WILLIAMSON COUNTY, TEXAS

CHANGE ORDER NUMBER: 6

Project:	<u>13IFB00108</u>
Roadway:	<u>IH 35 NBFR</u>
CSJ Number:	<u>0015-08-128, etc.</u>

Change Order No. 6

GAS UTILITY LOCATION
EXISTING 20-1 4" HP STEEL PIPELINE
IH-35 NBFR - STA. 272+77 CROSSING
GENERAL NOTES / PLAN & DETAIL

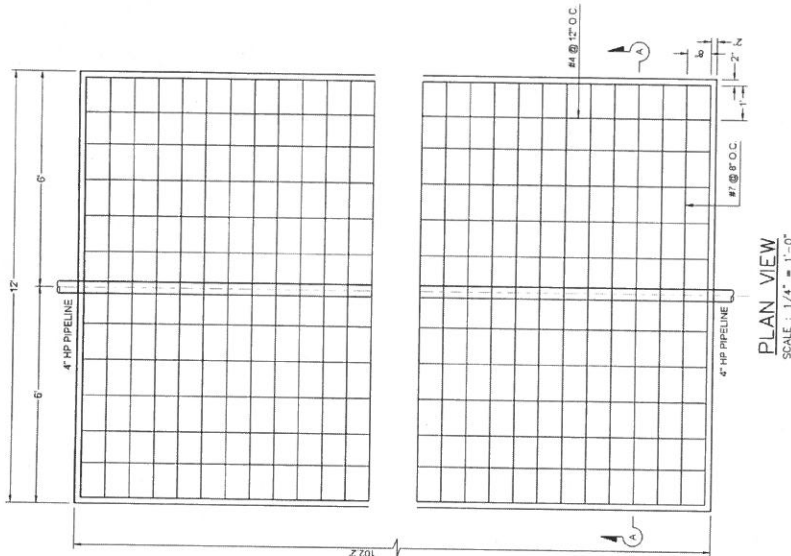
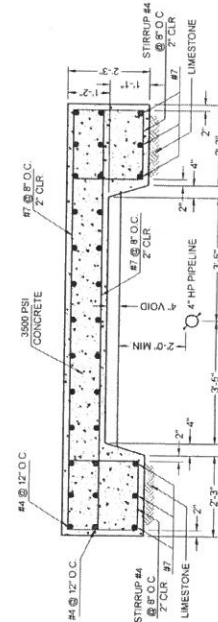
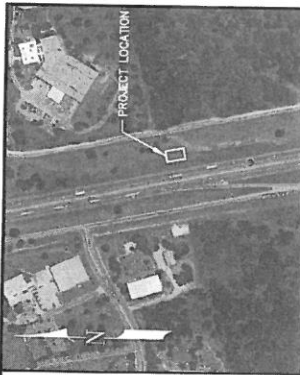
This Change Order increases the contract quantity of Class C concrete to provide compensation for construction of a concrete slab over an existing high pressure Atmos gas line, located under the future northbound frontage road at Sta. 272+77. Constructing a concrete slab to protect the gas line in lieu of utility relocation provides an overall cost savings to the County. This Change Order is FHWA non-participating.

Attached is the draft of Change order No. 6 adding 72.8 CY of concrete to the existing contract Item 420-2013 - CL C CONC (MISC) for the construction of the Load Isolating Structure/Protective Concrete Slab over the existing Atmos Gas line. This gas line crosses under the future IH 35 NBFR near the West Fork Smith Branch bridge and was required by TxDOT.
